Ogden Valley City
Planning Department
(385) 732-1340
planning@ogdenvalleyut.org

Staff Report – Updated 11/12/2026

Re: Conditional Use Permit for commercial campsite in the Forest-5 Zone

Prepared by: Brian Carver, AICP

Figure 2

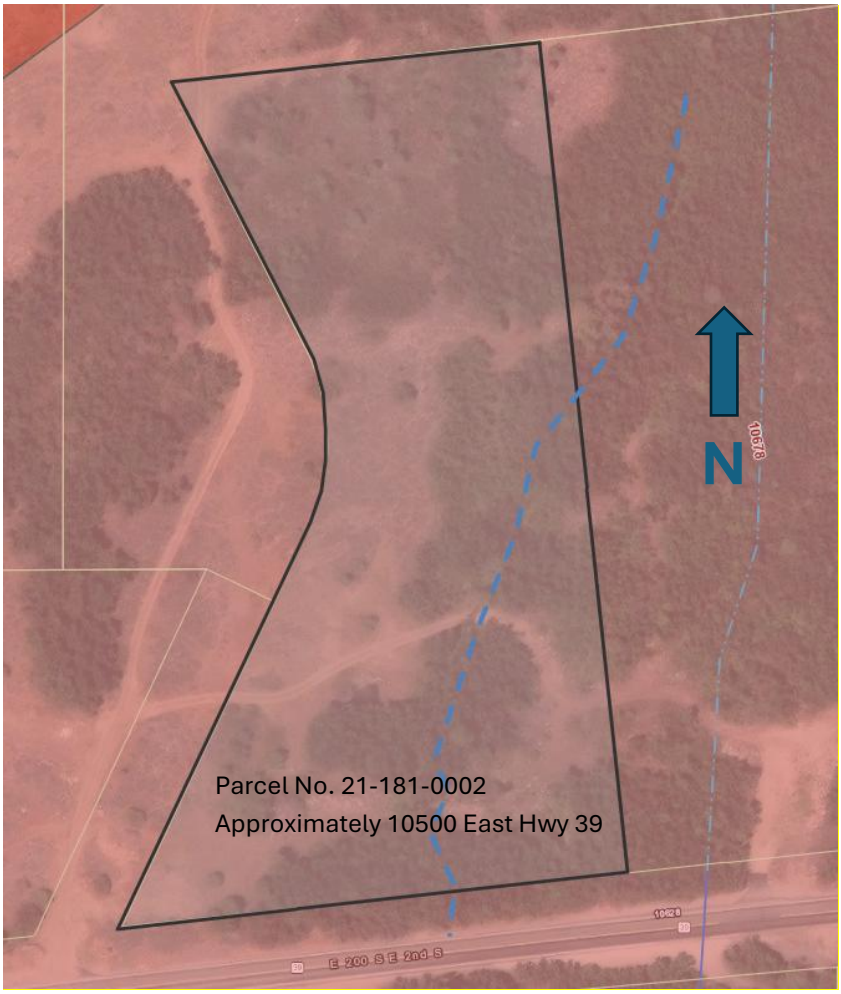
Due to the QAFY soils designation shown on the Weber County Geological Map and the site plan showing an intermittent spring, staff reviewed the proposed uses' effects in relation to sensitive lands(see Figure 2). The geological map shows the subject parcel is designated as QAFY. QAFY soils is composed of mostly poorly bedded and poorly sorted, mostly unconsolidated sand, silt, and gravel; impinge on present-day floodplains, divert active streams, and overlie low terraces. A Geotech report was provided due to the QAFY designation (see attached). The report did not identify any active landslide areas, areas of instability, or areas where development could increase the risk of slope failure in relation to the subject property (Parcel 9).

The 2008 Ogden Valley Sensitive Lands Stream Corridors map shows an intermittent stream/spring running north-south through the neighboring eastern parcel but does not show a stream/spring through the subject site (see Figure 2). The subject parcel is part of a recorded plat for Gateway Estates Subdivision Phase 1A. The plat shows seasonal stream/drainage and no build zone and stream protection zones within the parcel to the east, not within the subject parcel. The City Engineer has confirmed that the water course is present on the applicant’s parcel, as illustrated in the provided site plans. It is a seasonal ephemeral stream, requiring a 50-foot no-build zone on either side according to **Ogden Valley City Land Use Code Title 104-28-2 Sensitive Lands Overlay: Stream Corridors, Wetlands, and Shorelines.**

1. An emergency evacuation plan in relation to the intermittent stream/spring will be provided before final issuance of the certificate of occupancy.
2. Site modifications will ensure the proper maintenance of the intermittent spring/stream and will not build structures or sites within the designated area.
